HENZLEE PLACE STREET
IMPROVEMENT PLAN

HENZLEE PLACE STREET IMPROVEMENT PLAN

SOPHIA LANE STREET IMPROVEMENT PLAN

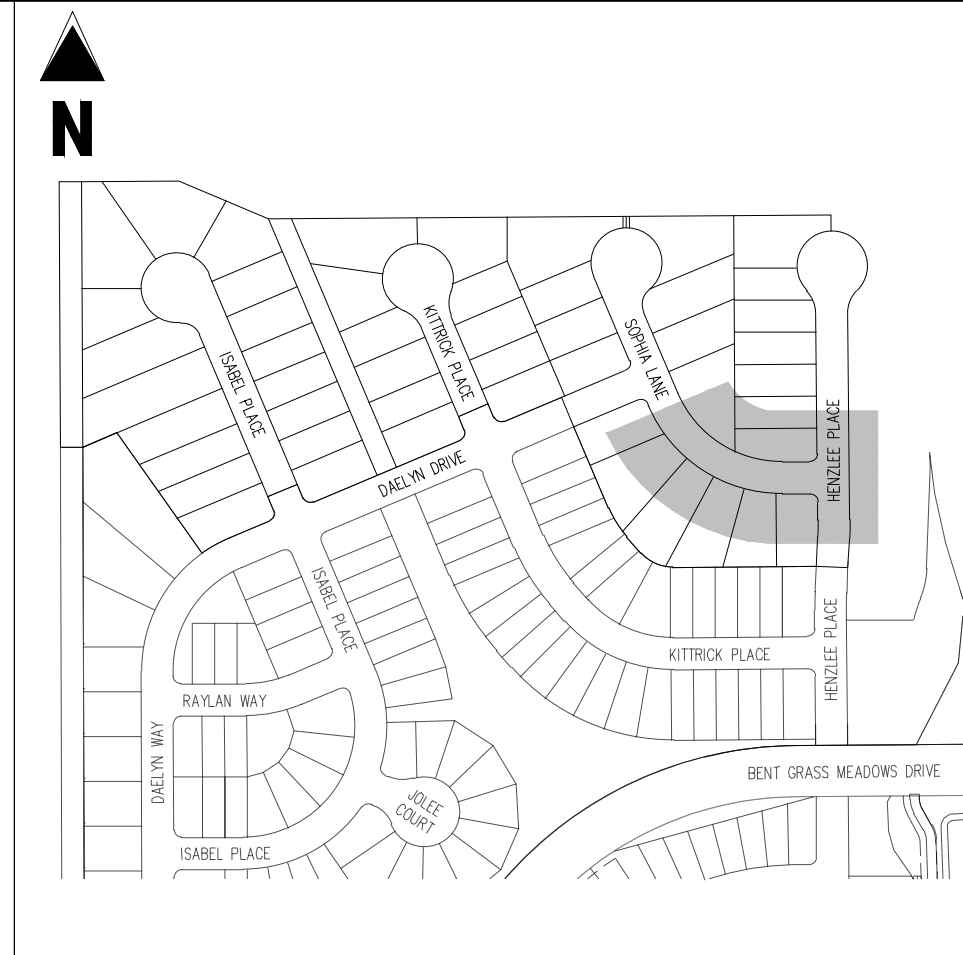
Please indicate the grade at the cul-de-sac bulb. Per ECM figure 2-31, the max slope shall be 3%

SOPHIA LANE (STREET D - CUL-DE-SAC)
STA: -0+25 - 3+50 SCALE: H: 1"=30' V: 1"=3'

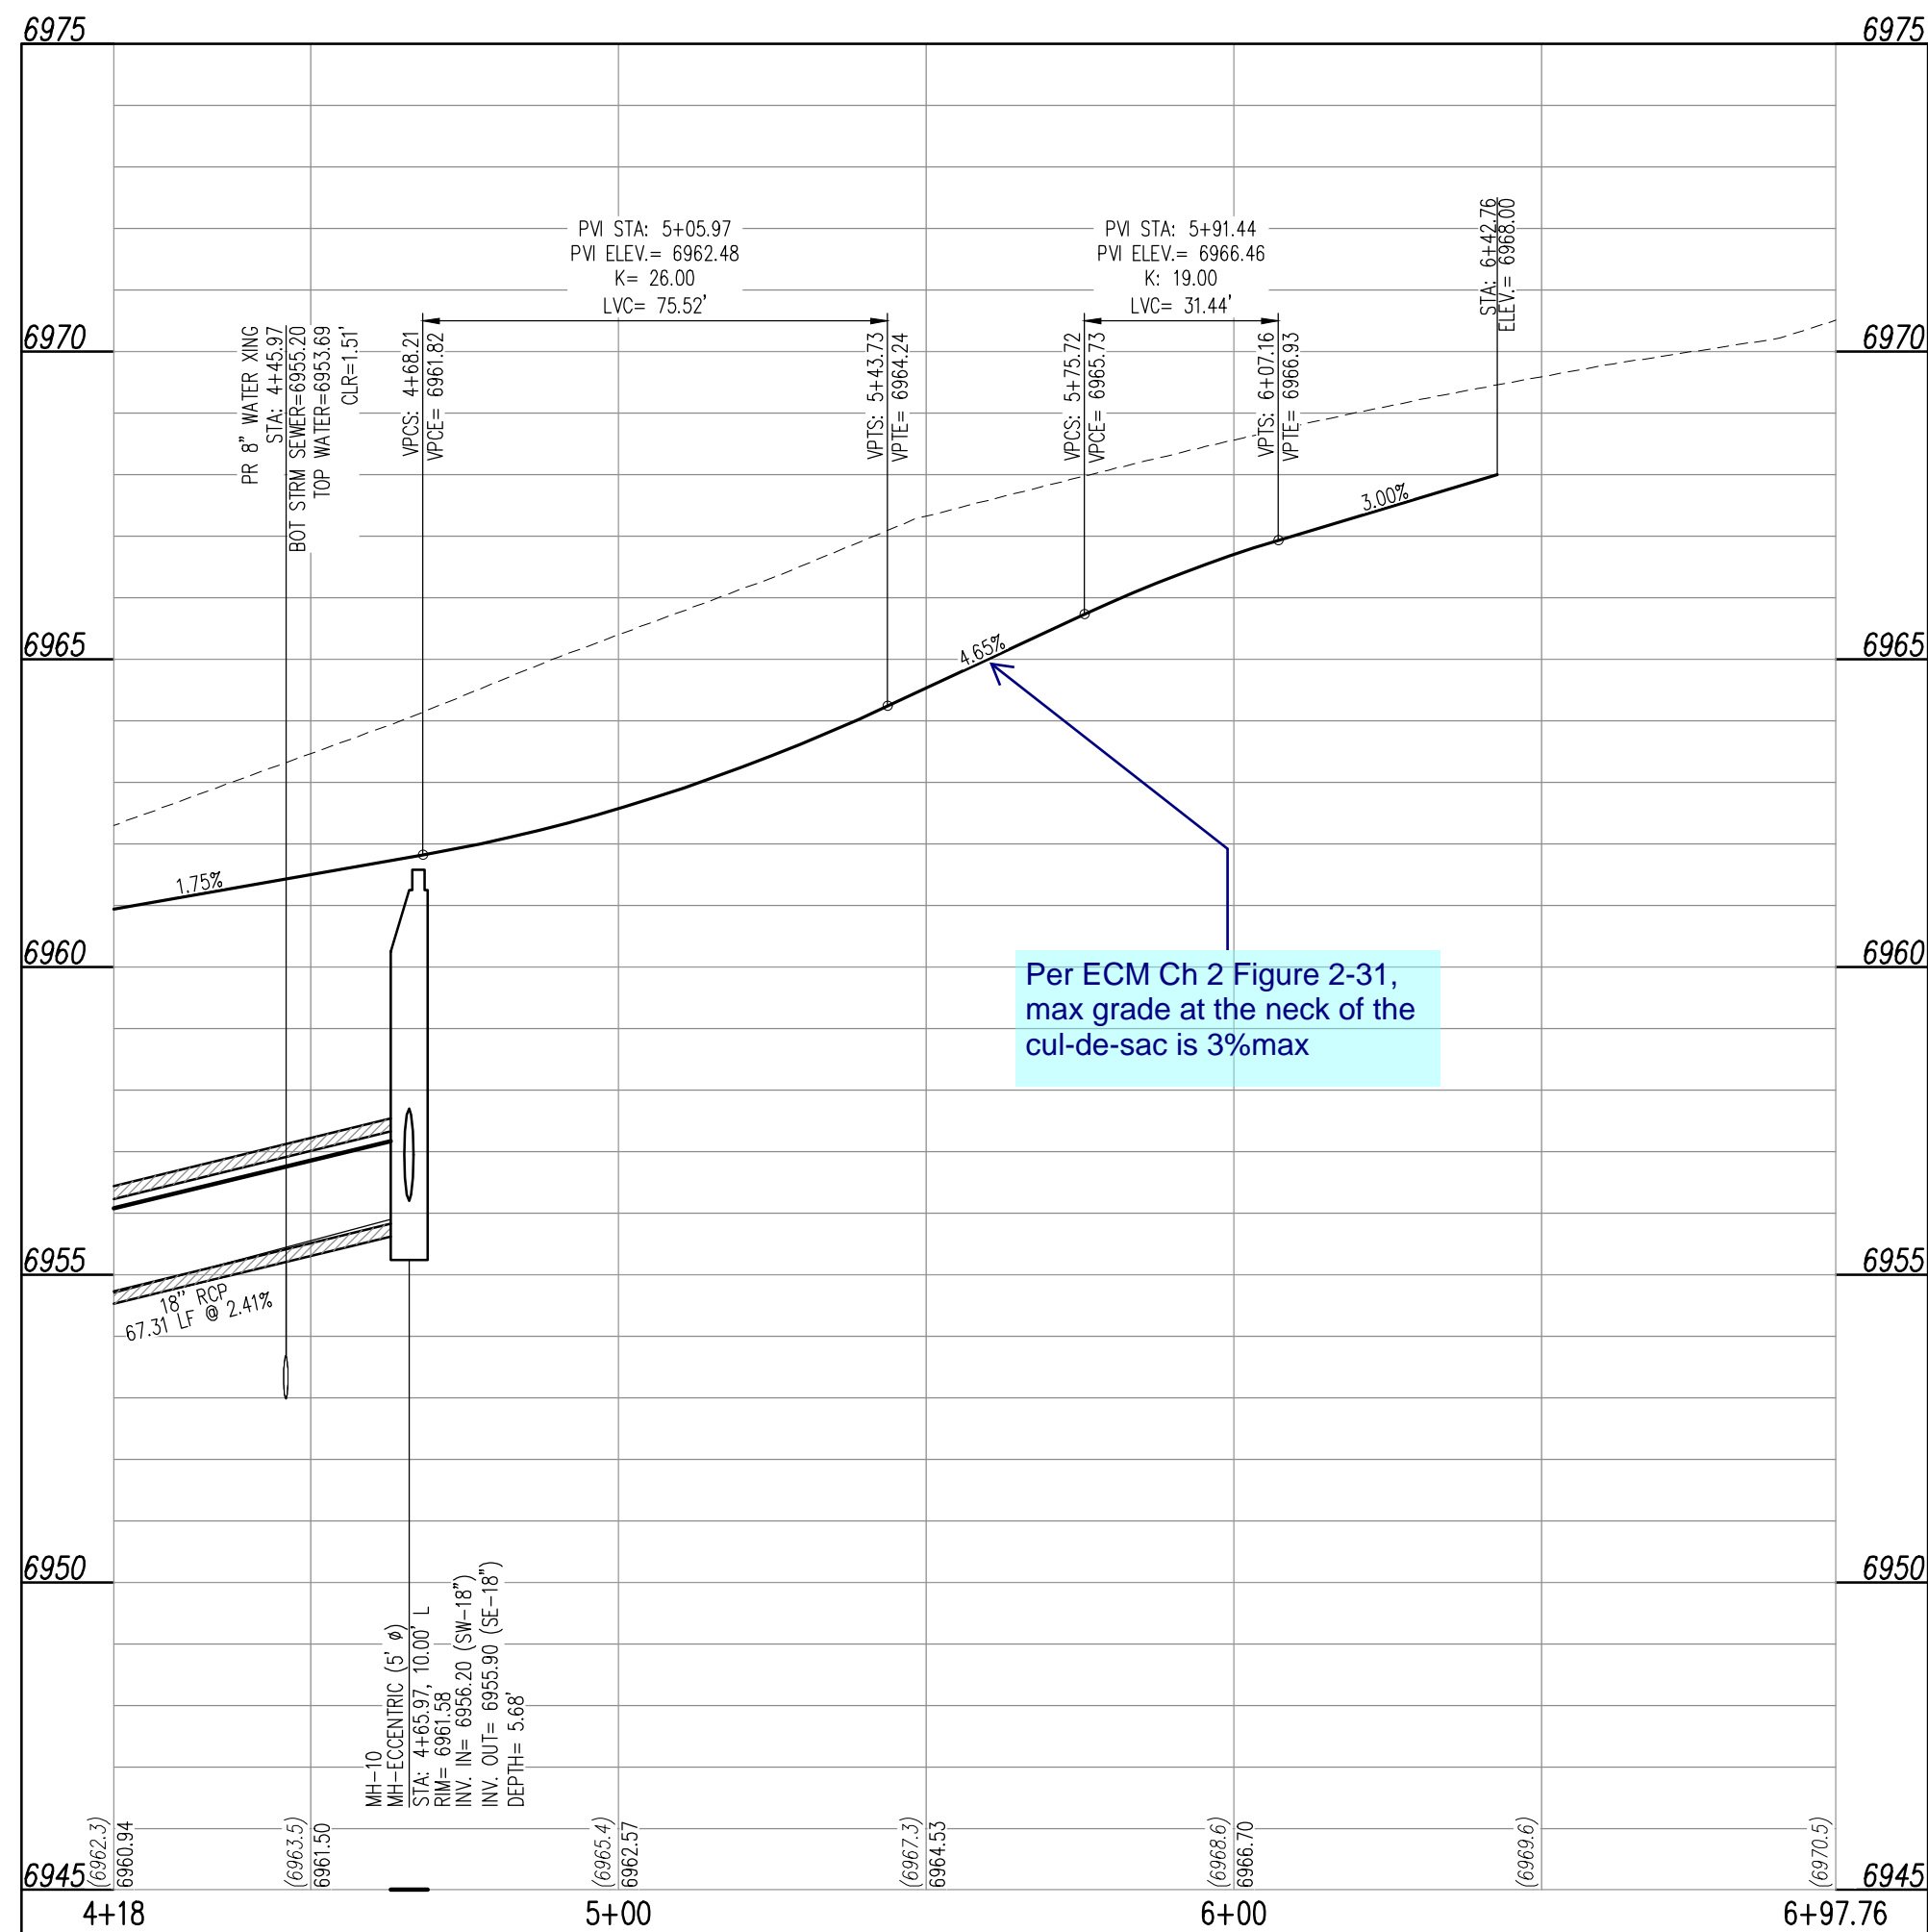
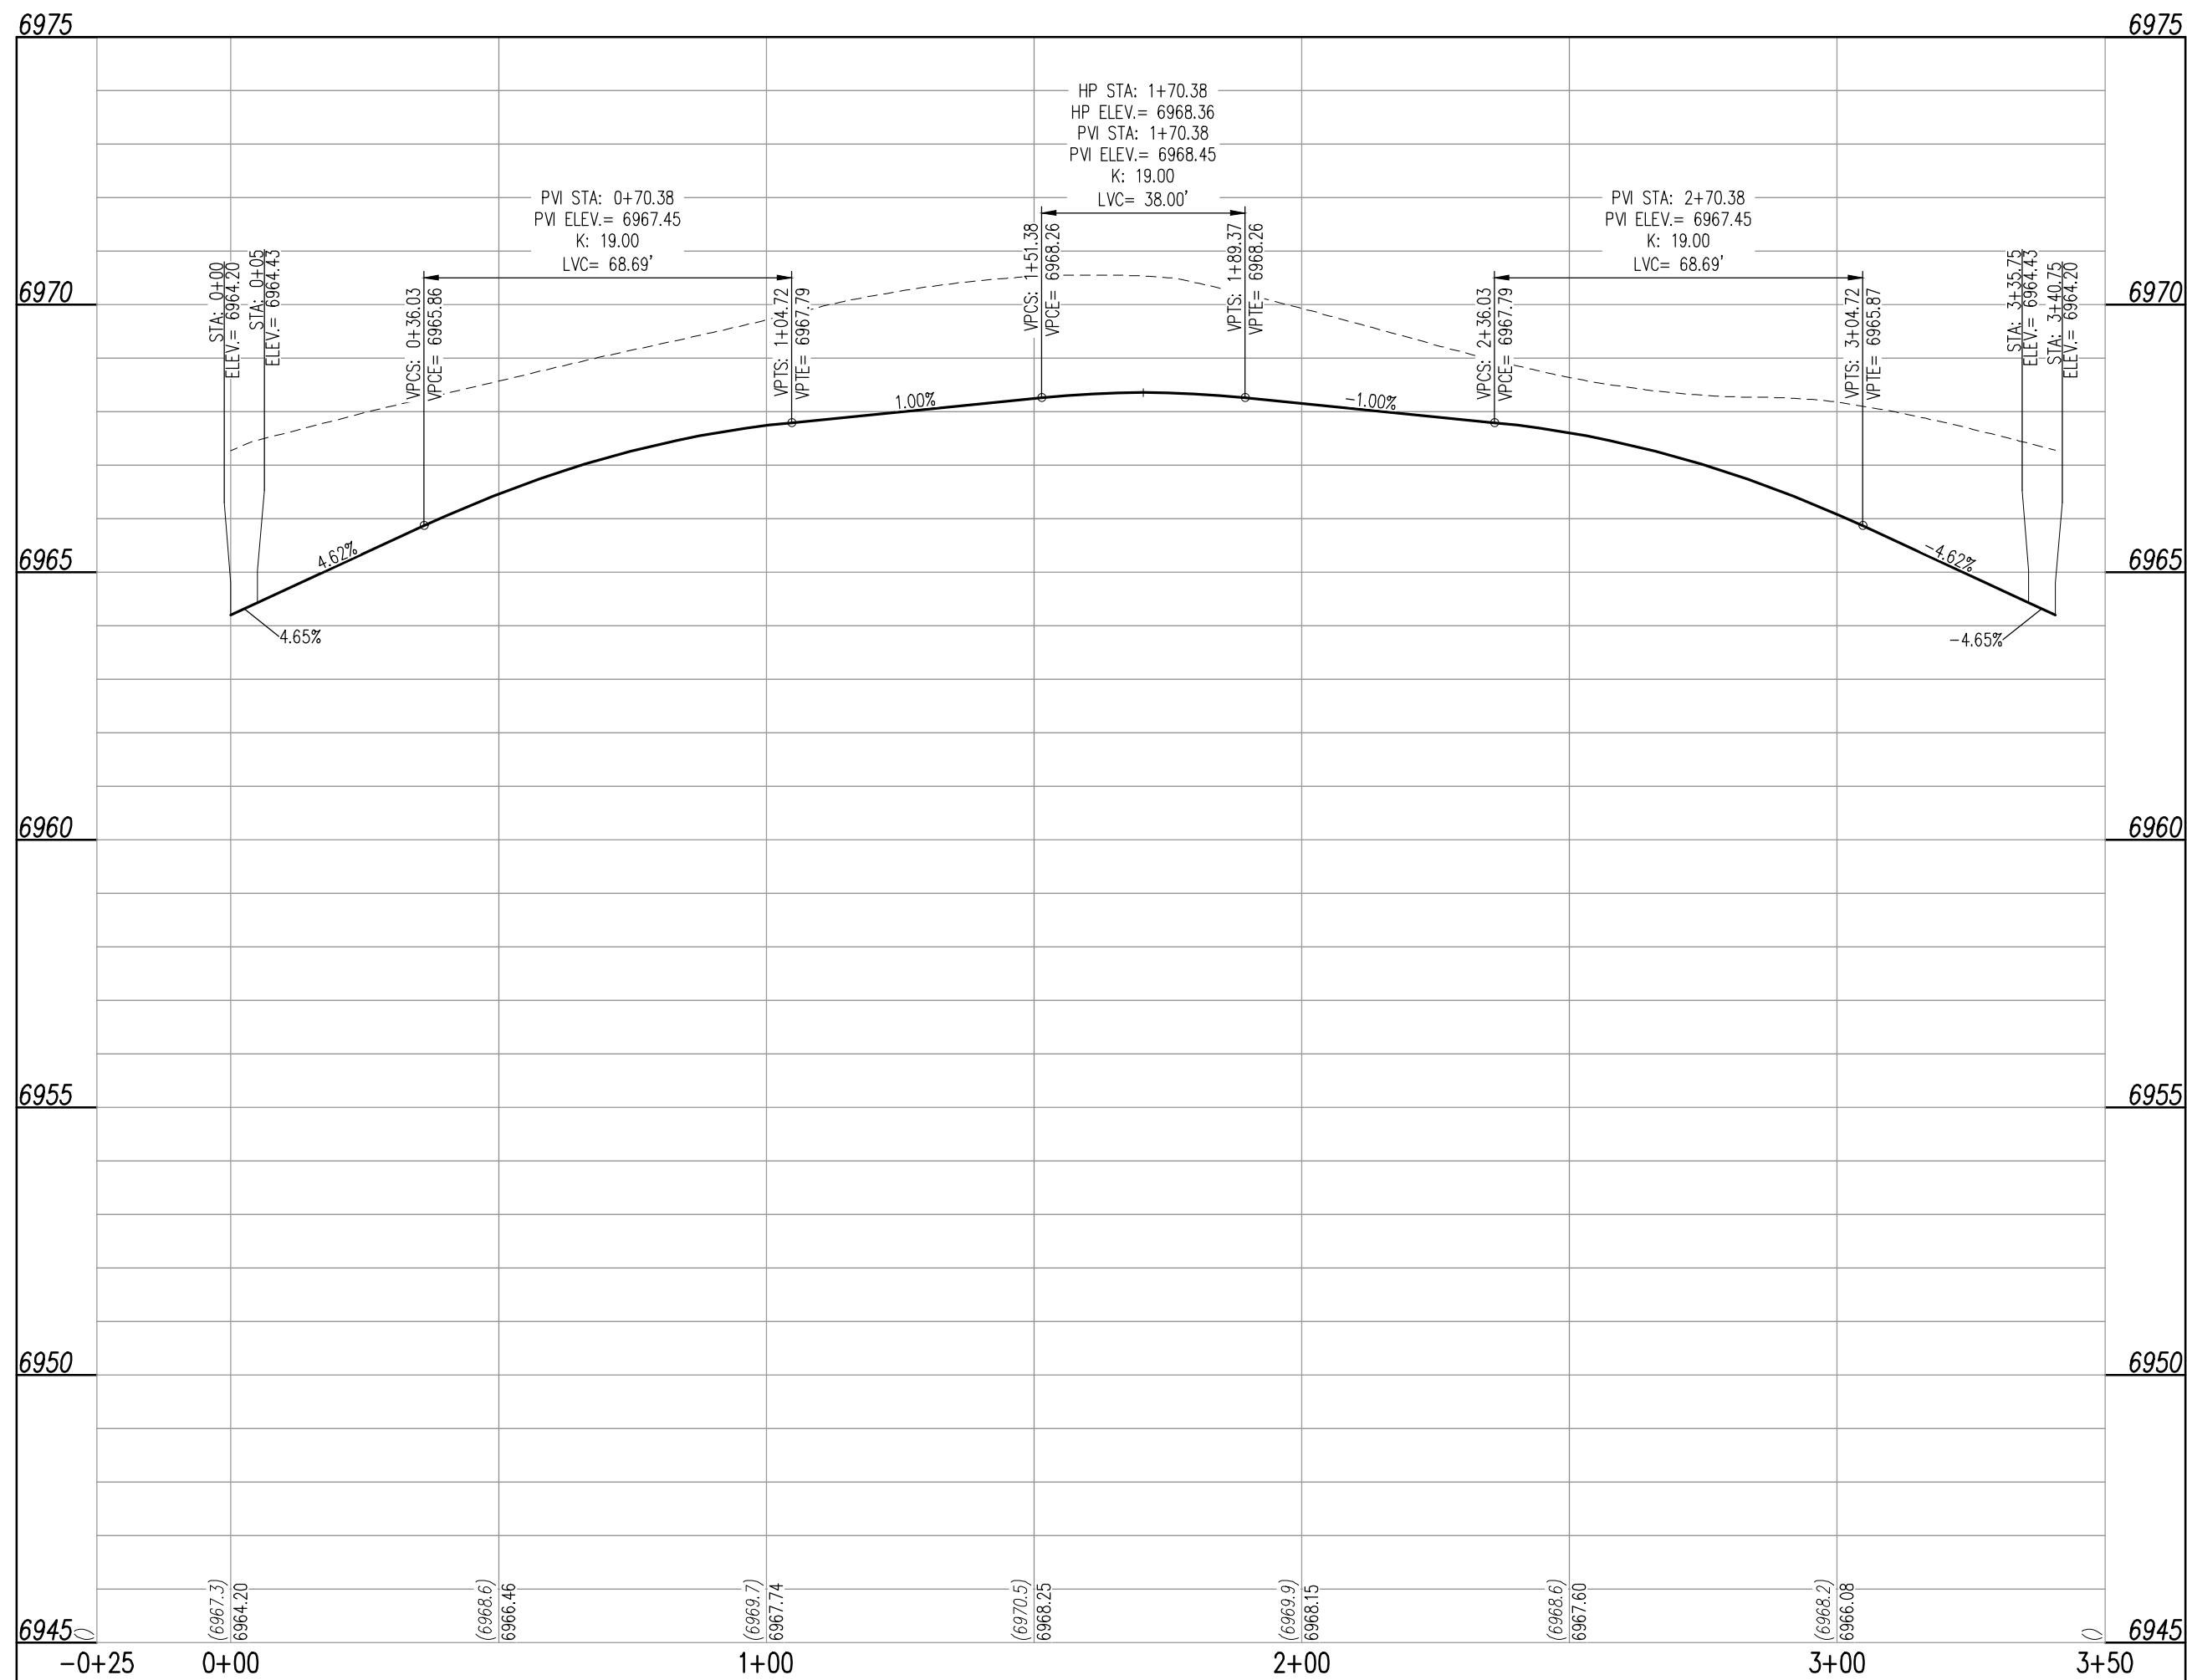
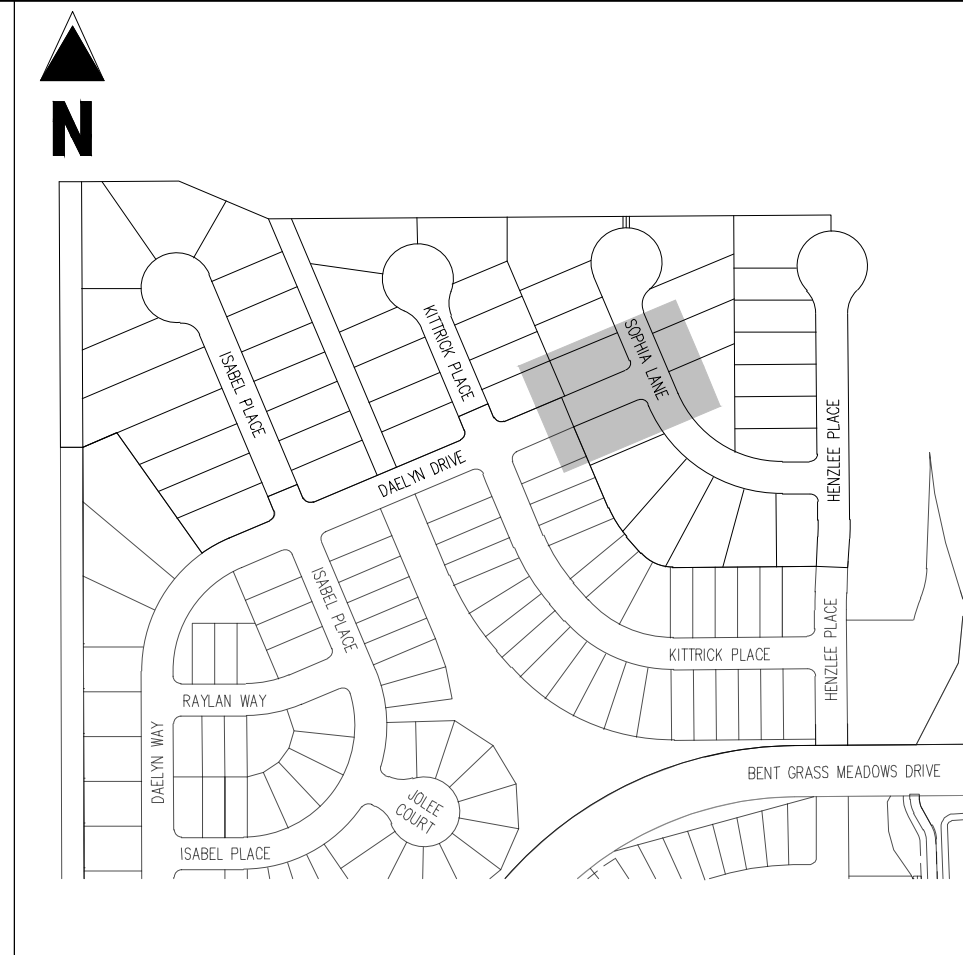
Per EPC standard
detail SD_2-75 min.
radius shall be 45'.
revise accordingly.
